CITY OF ALBUQUERQUE

Re: Louisiana Plaza
7200 Montgomery Blvd NE
Traffic Circulation Layout
Engineer's/Architect's Stamp 10-21-19 (G19D016A)

Based upon the information provided in your submittal received 10-31-2019, the above referenced plan cannot be approved for Building Permit until the following comments are addressed:

6 SIGN MOUNTING DETAIL

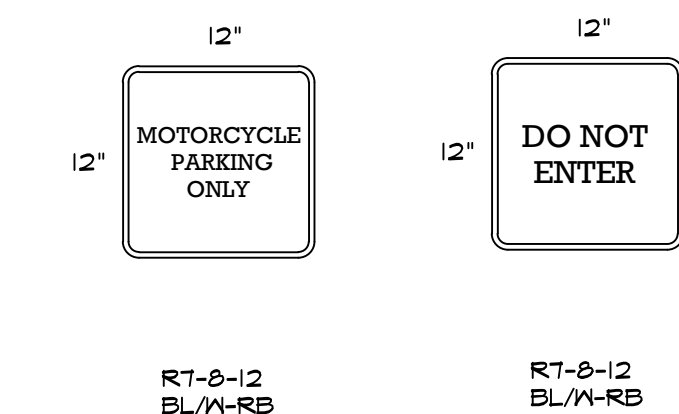
4. The ADA accessible parking sign must have the required language per 66-7-352.4C NMSA 1978 "**Violators Are Subject to a Fine and/or Towing.**" Please call out detail and location of signs.

PARTIAL SITE PLAN

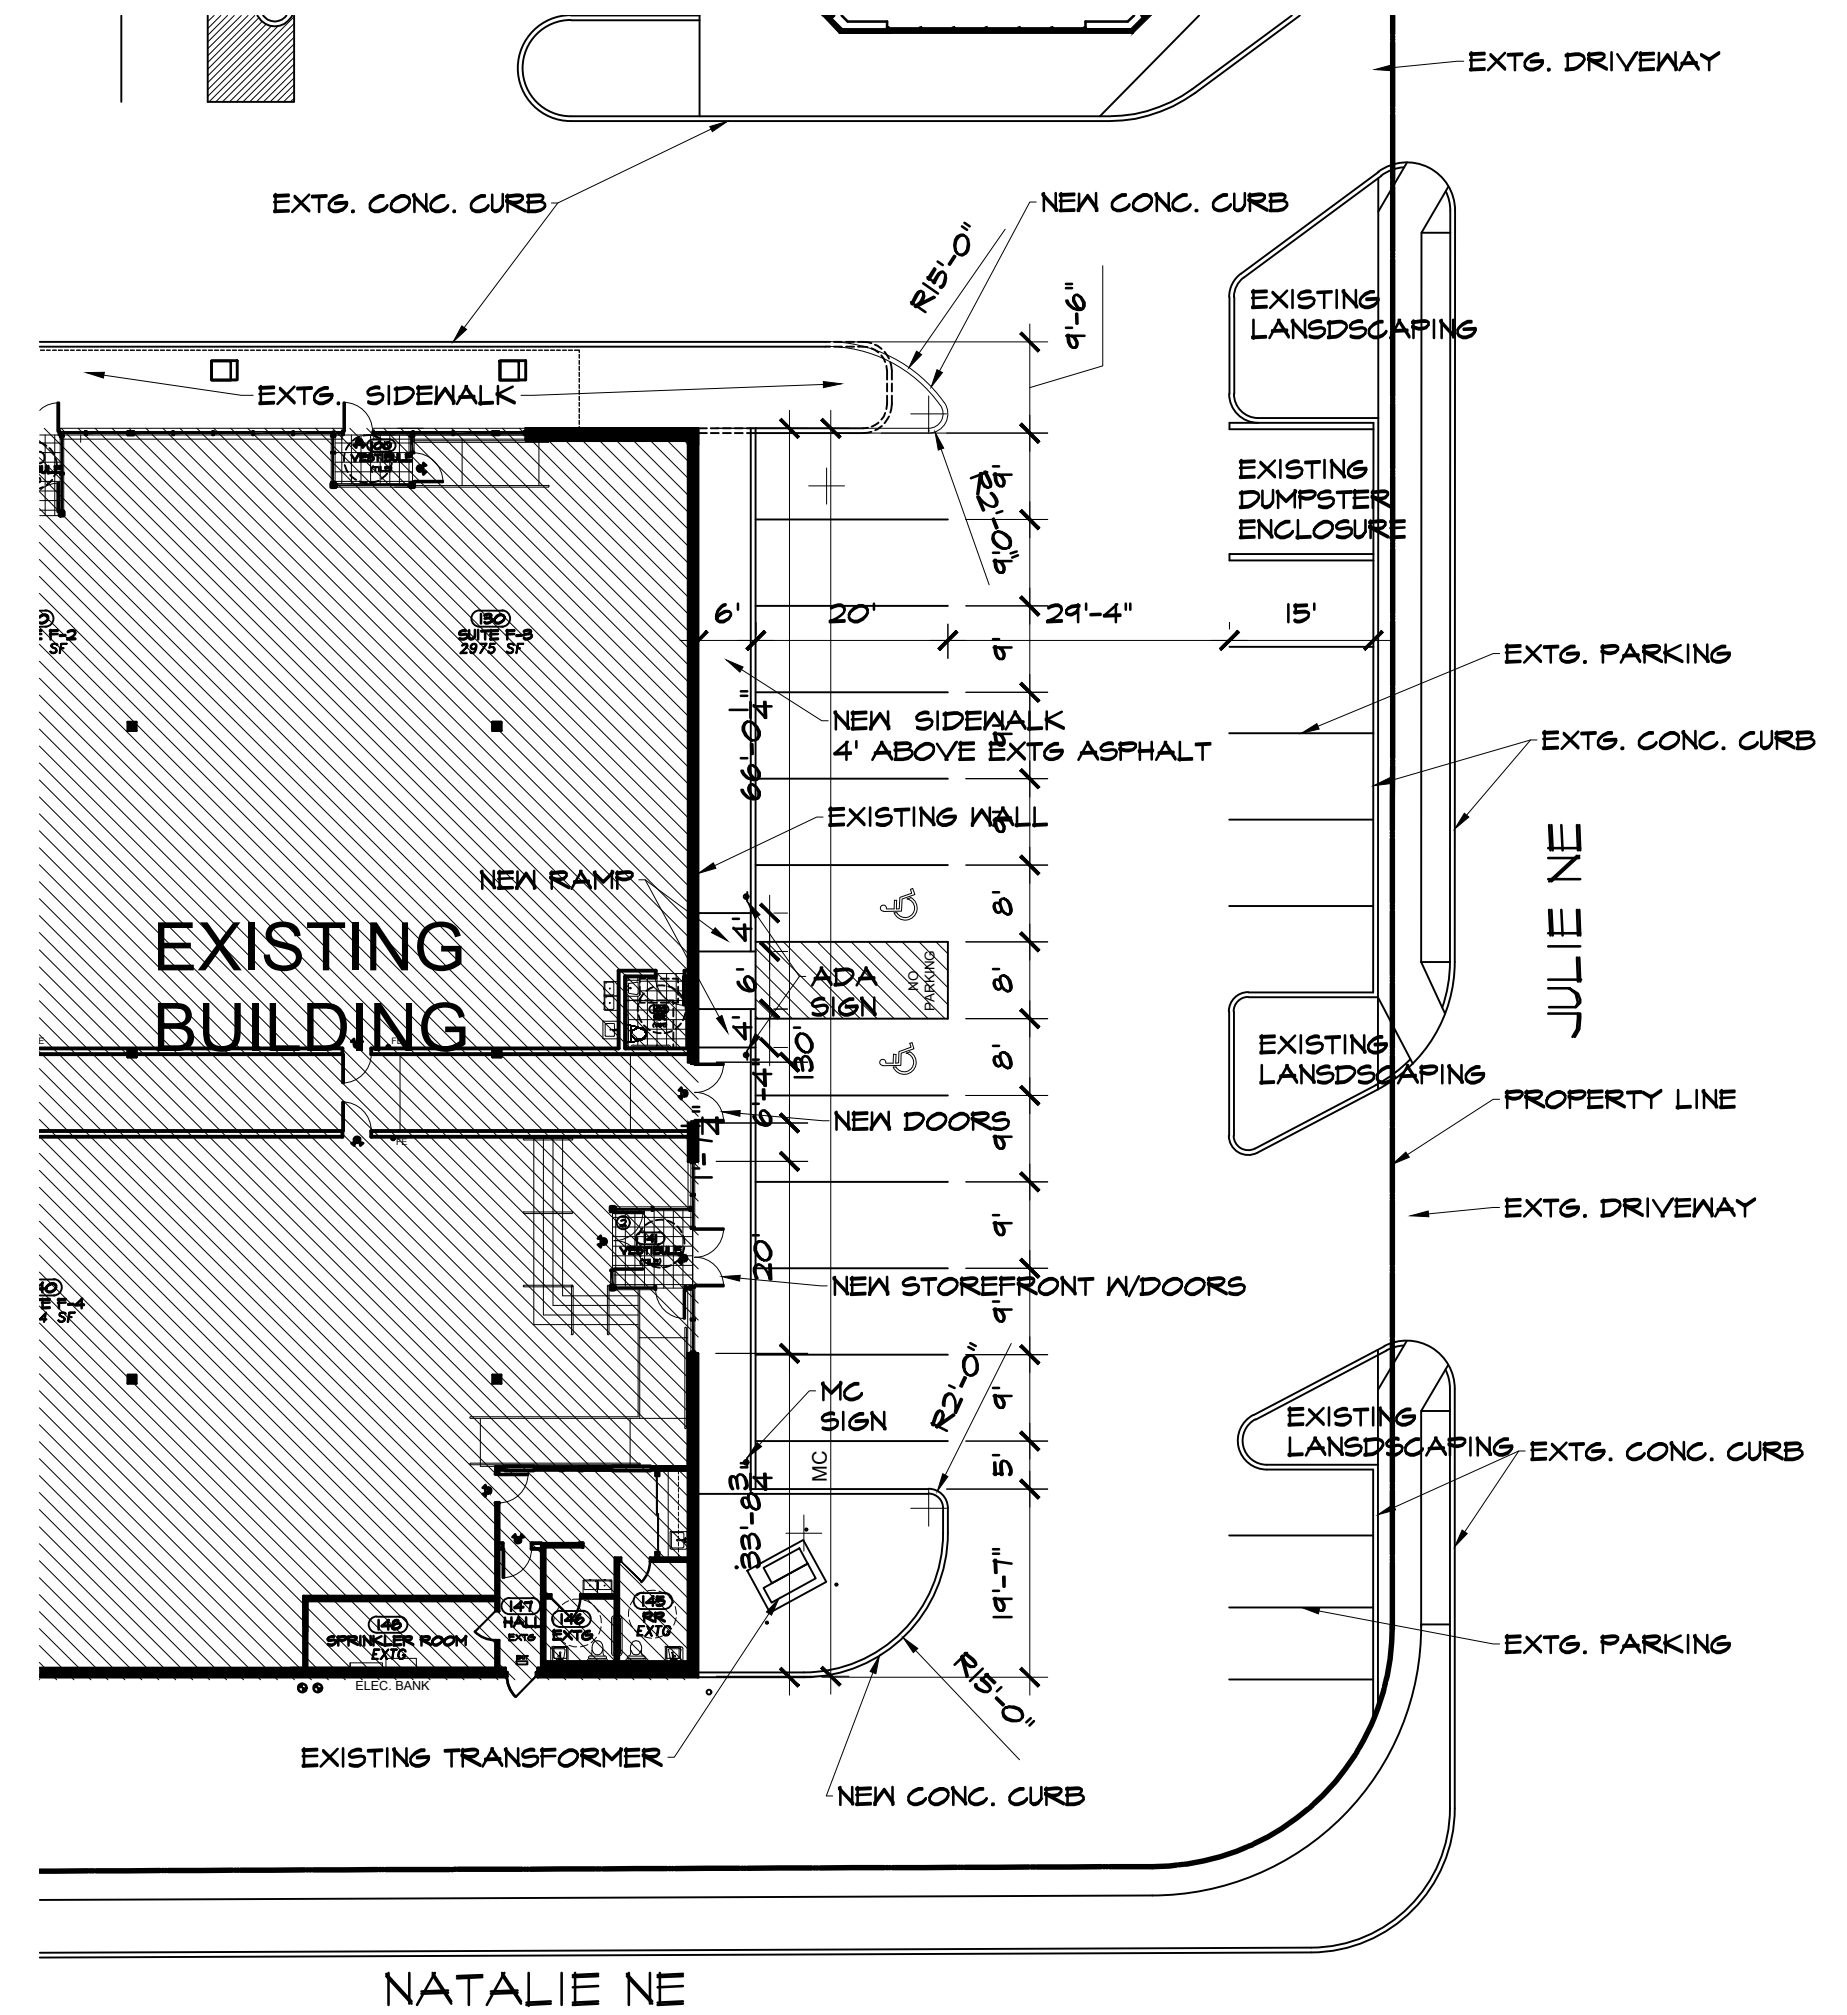
1. List the number of parking spaces required by the zoning code as well as the proposed number of parking spaces including bicycle and motorcycle parking.

2. Please list the width and length for all existing and proposed parking spaces. Some dimensions are not shown.
3. Label the compact parking spaces by placing the words "**COMPACT**" on the pavement of each space.

5. All bicycle racks shall be designed according to the following guidelines:
 - a. The rack shall be a minimum 30 inches tall and 18 inches wide.
 - b. The bicycle frame shall be supported horizontally at two or more places. Comb/toaster racks are not allowed.

- c. The rack shall be designed to support the bicycle in an upright position. See the IDO for additional information.
 - d. The rack allows varying bicycle frame sizes and styles to be attached.

- e. The user is not required to lift the bicycle onto the bicycle rack.
 - f. Each bicycle parking space is accessible without moving another bicycle.

6. Bicycle racks shall be sturdy and anchored to a concrete pad.
7. A 1-foot clear zone around the bicycle parking stall shall be provided.
8. Bicycle parking spaces shall be at least 6 feet long and 2 feet wide.

9. Per the IDO, a 6 ft. wide ADA accessible pedestrian pathway is required from the public sidewalk to the building entrances. Please clearly show this pathway and provide details.
